Objection to Policy E2

Flawed reasoning for de-allocation

PROJECT TITLE	HAYLING FARM BRIDGE STR: E15/37 ELR: SDP1 MILEAGE: 11.0041
DRAWING TITLE	LOW LEVEL BRIDGE PLAN SHOWING PROPOSED ROAD ARRANGEMENT AND SECTIONS

Hayling Farm Underbridge

Page 1 of 2	Document Review Notice (DRN)				
	Form Ref	NR/L2/INI/02009/F0044	Issue Date	05/09/2015	Issue

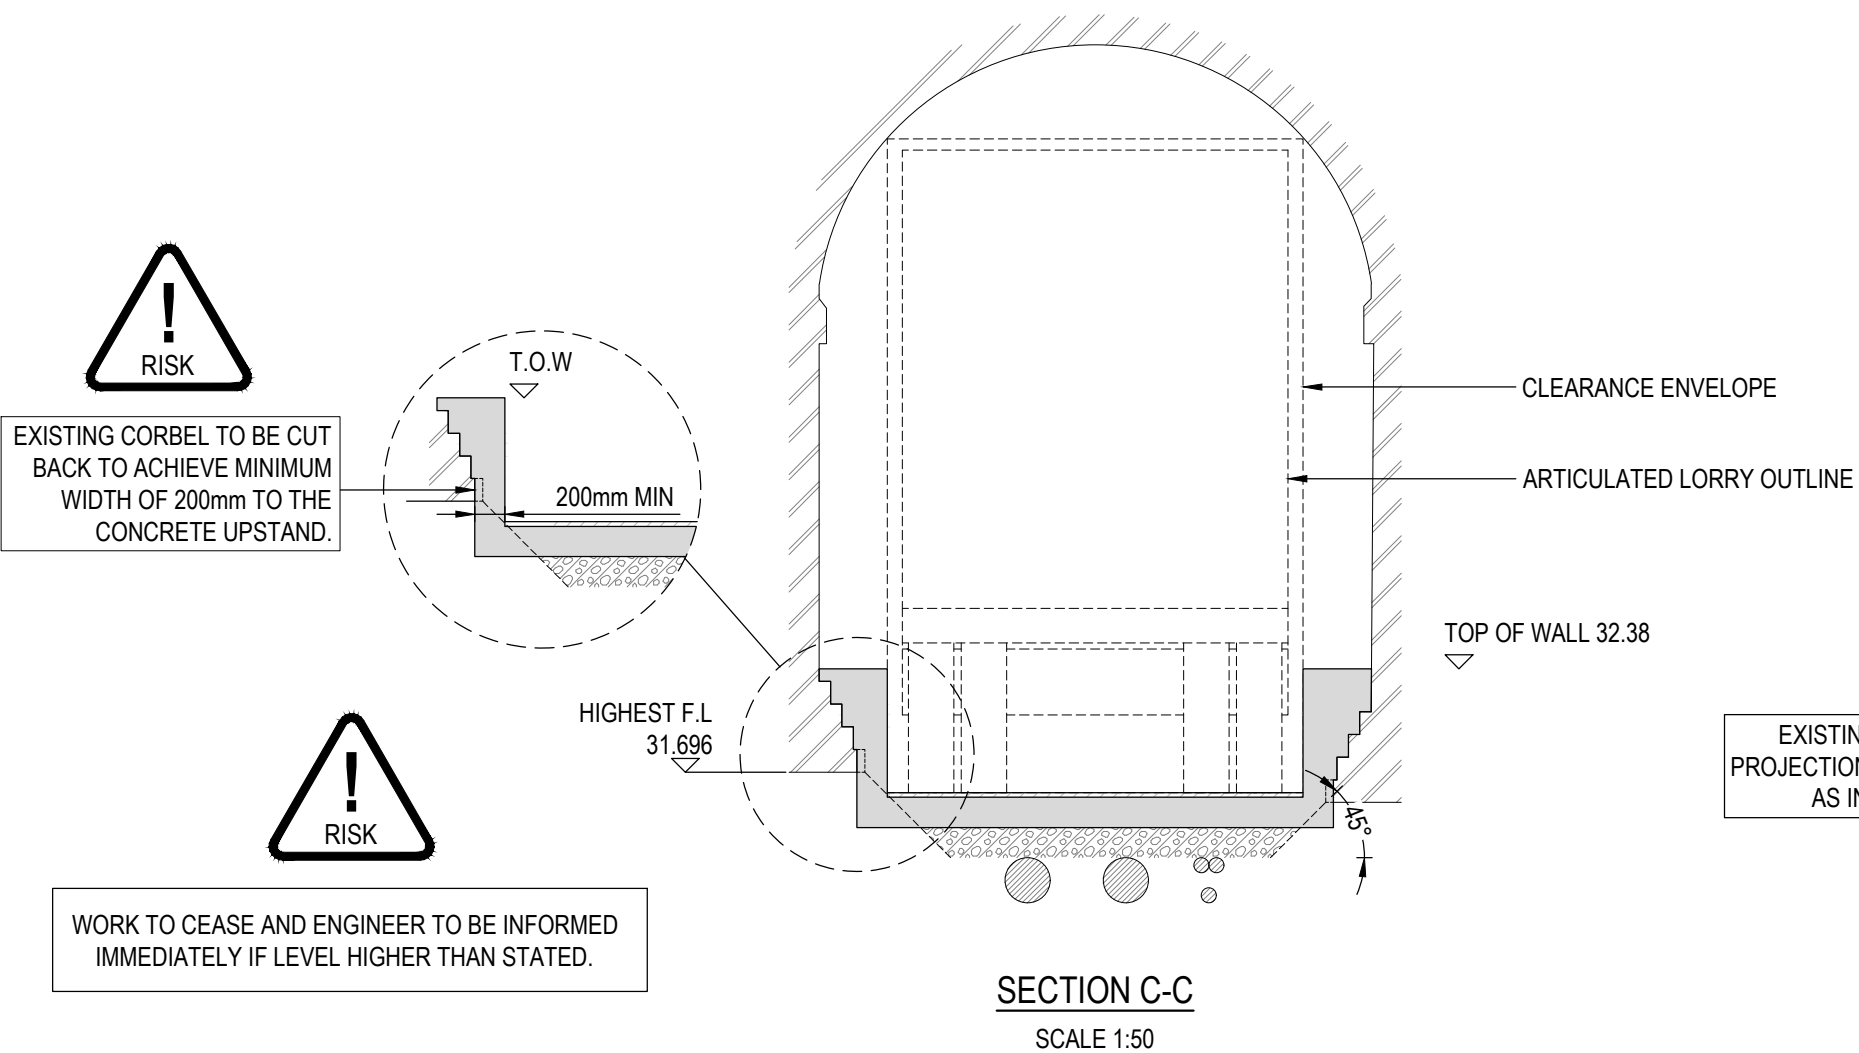
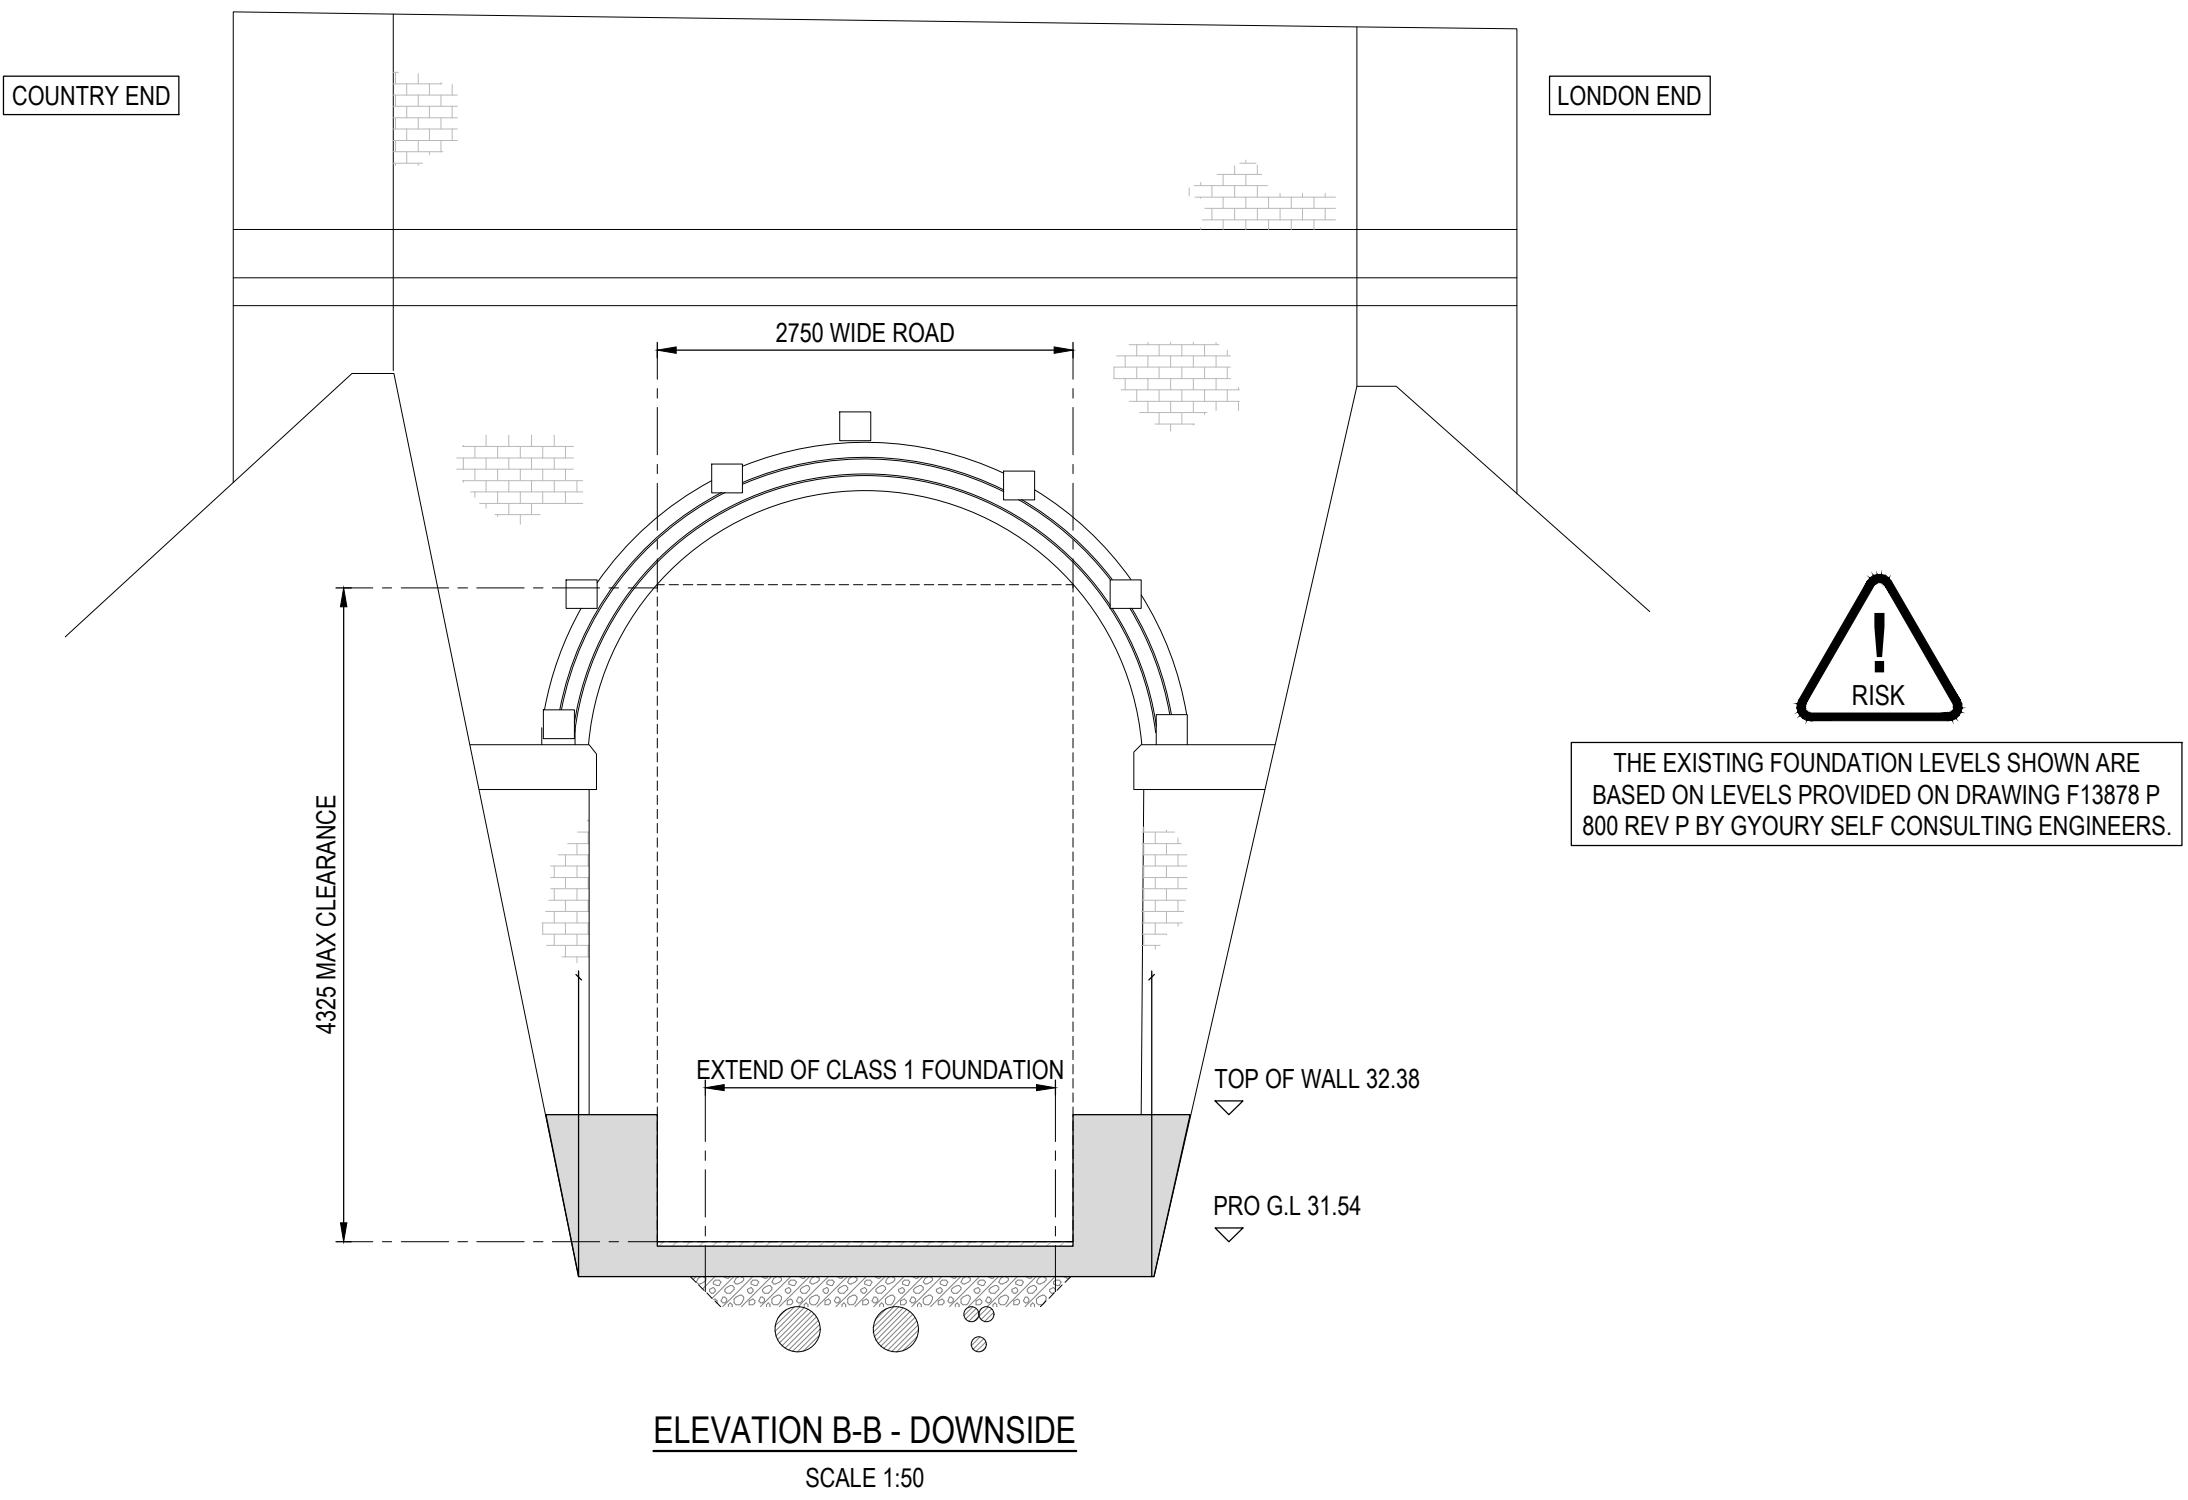
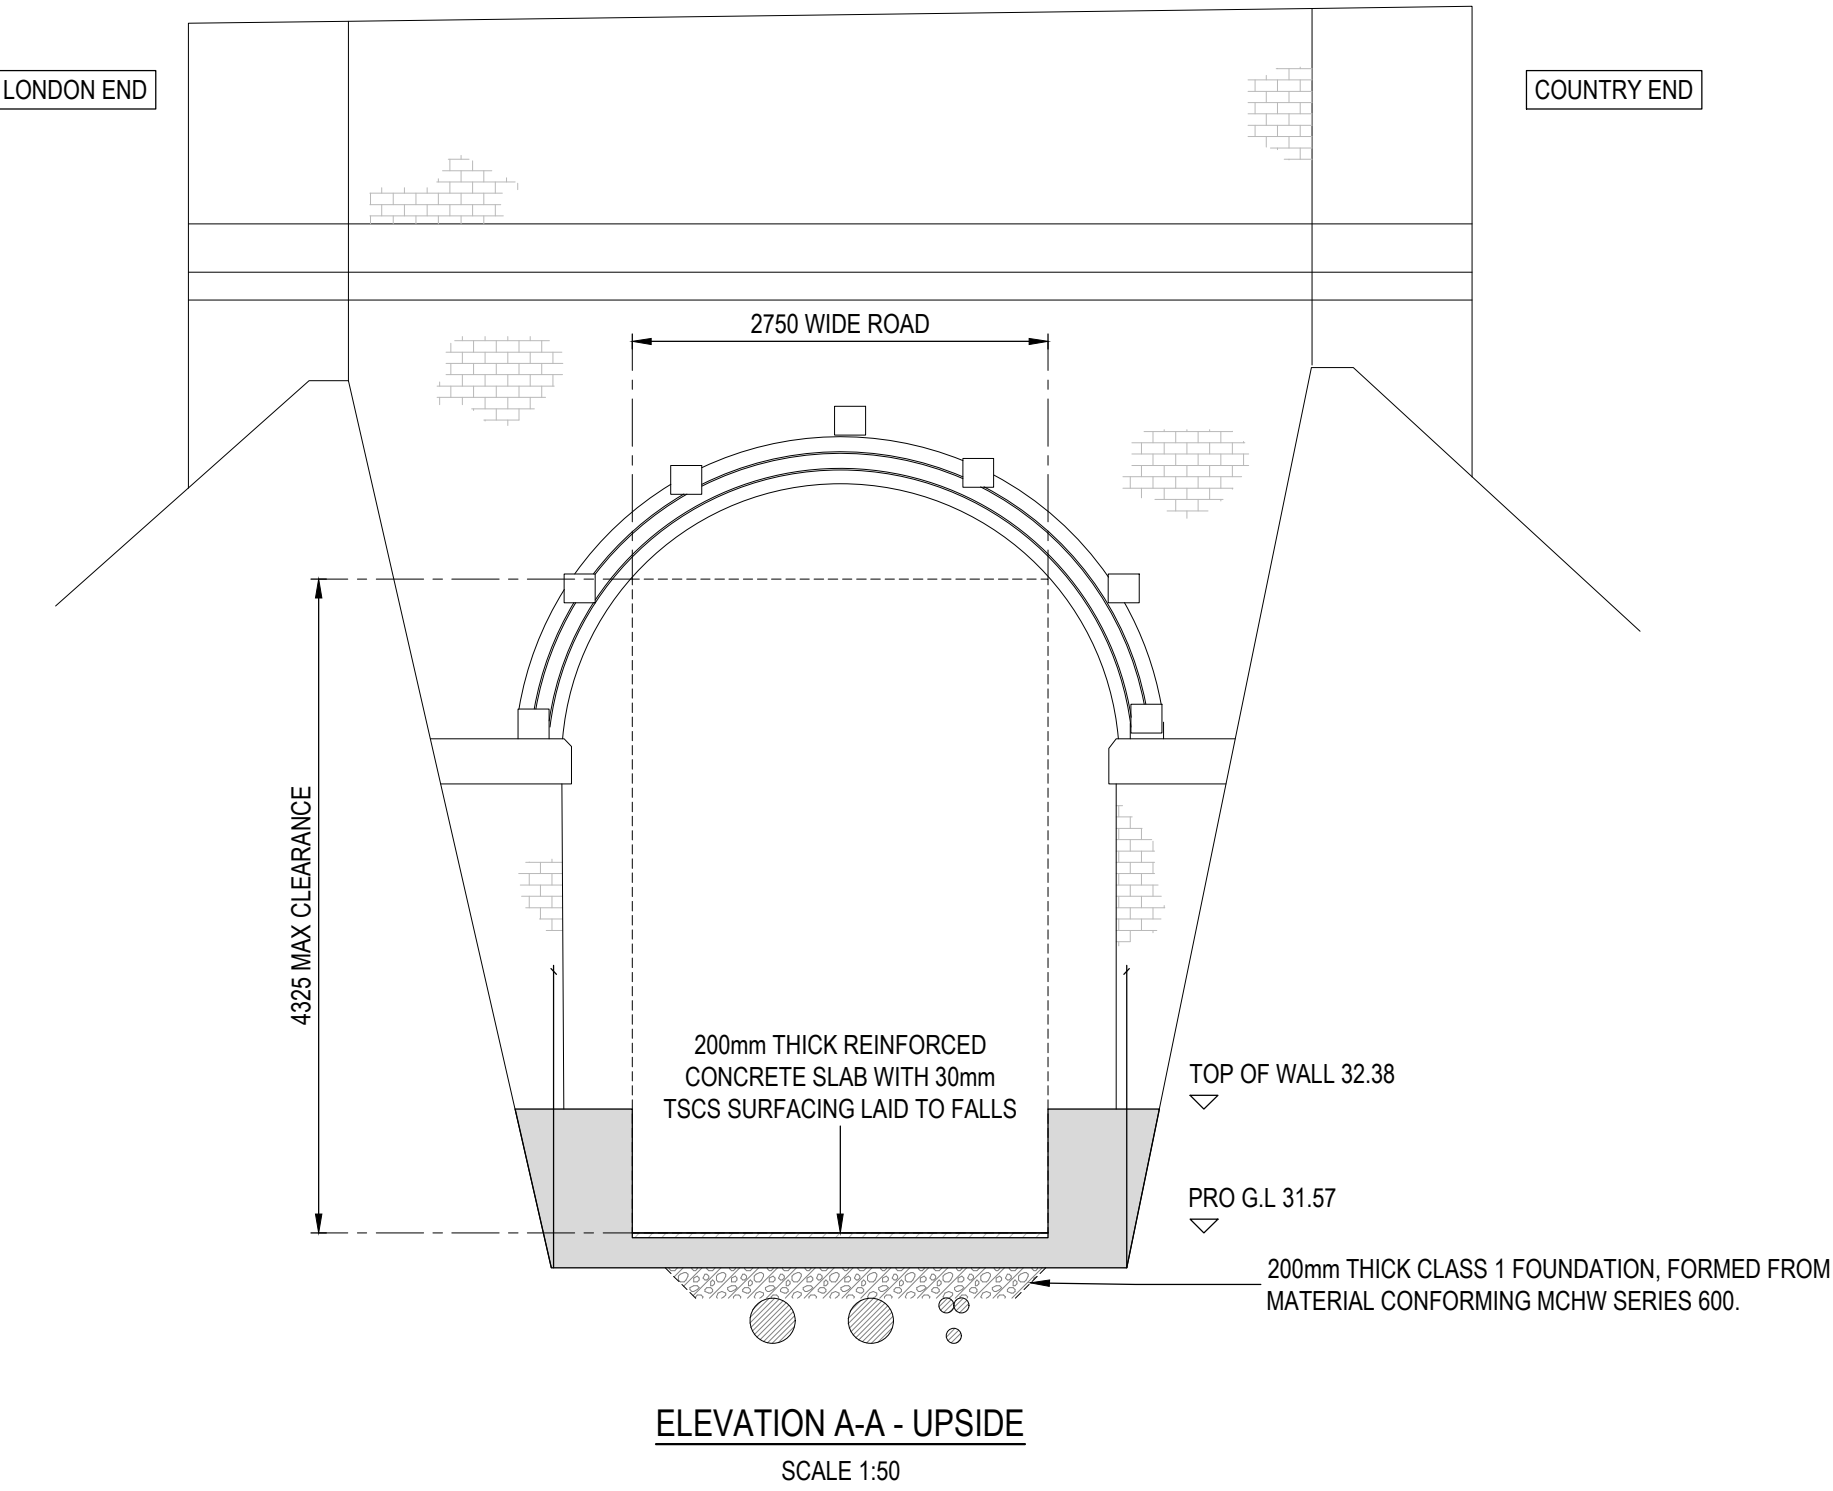
Page 2 of 2		Document Review Notice (DRN)				DRN No: WE1151	
Form Reference		NR/L2/INI/02009/F0044		Issue Date	05/09/2015	Issue	8.0
Network Rail (NR)		Supplier				NR	
No	Comments	By	Type	Integration Activity	Comment Accepted	Responses	By
1	Google streetview shows a wide crack in intrados approximately 1m from North West corner. An investigation should be undertaken to assess cause of cracking. Also any other defects present on the bridge should also be identified. Remedial works to the defects identified should be undertaken prior to main works.	AB	3A				
2	Monitoring of the underbridge should be undertaken during construction. The monitoring should be taken on a regular basis, even during night time, preferably using a remote equipment.	AB	2A				
3	The risk assessment did not include the risk of the abutment foundations moving together as a result of the removal of passive restraint. This needs to be addressed with adequate mitigation.	AB	3A

4	A method statement will be required before the work is undertaken. We would expect emergency propping equipment to be available on site in case any movement was detected in the abutments.	AB	4				
5							
6							
7
